Access Compliance Report

Public Rights-of-Way

(Curb Ramps)

Intersection ID: 14612		Main Street: BAXTER_ST		Cross Street: MAIN_ST		Location: SE			
ADA ID: D0F36EBDCCA8		Ramp Type: PerpDiag		Initial Pass/Fail: Fail		Overall Compliance: No		Severity Score: 60	
Codes/Mitigation Info/Possible Solution					Field Measurements/Component Compliance

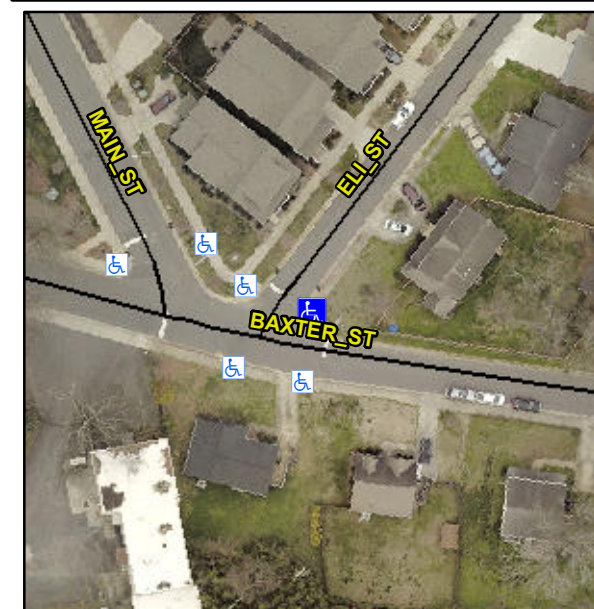
Not Found, R304.5.1, R304.2.2, R304.5.3

Compliance	Description	Data	Compliance	Description	Data
N/A	Ramp Length (in)	60.0	No	Ramp Slope (%)	11.4
No	Ramp Width (in)	29.0	No	Ramp XSlope (%)	5.5
N/A	Flare Type LT	N/A	N/A	Flare Type RT	N/A
N/A	Flare Slope LT (%)	N/A	N/A	Flare Slope RT (%)	N/A
N/A	Flare Traversable LT?	N/A	N/A	Flare Traversable RT?	N/A
N/A	Landing Length (in)	N/A	N/A	DWS Provided?	N/A
N/A	Landing Width (in)	N/A	N/A	DWS Contrast?	N/A
N/A	Landing Slope (%)	N/A	N/A	DWS Length (in)	N/A
N/A	Landing X Slope (%)	N/A	N/A	DWS Full Width?	N/A
N/A	Landing Curb? (Y/N)	N/A	N/A	DWS Offset (in)	N/A
N/A	Shared Landing?	N/A			
N/A	Gutter Ponding?	N/A	N/A	Gutter Slope (%)	N/A
N/A	Gutter Lip Ht (in)	N/A	N/A	Gutter X Slope (%)	N/A
N/A	Painted X Walk1?	No	N/A	Painted X Walk2?	No
	X Walk 1 Direction	To NW		X Walk 2 Direction	To SW
N/A	X Walk 1 Width (in)	N/A	N/A	X Walk 2 Width (in)	N/A
	X Walk 1 Slope (%)	2.7		X Walk 2 Slope (%)	1.8
	X Walk 1 X Slope (%)	7.6		X Walk 2 X Slope (%)	1.1

Remove & Replace Curb Ramp With Two New Directional Ramps or Equivalent.
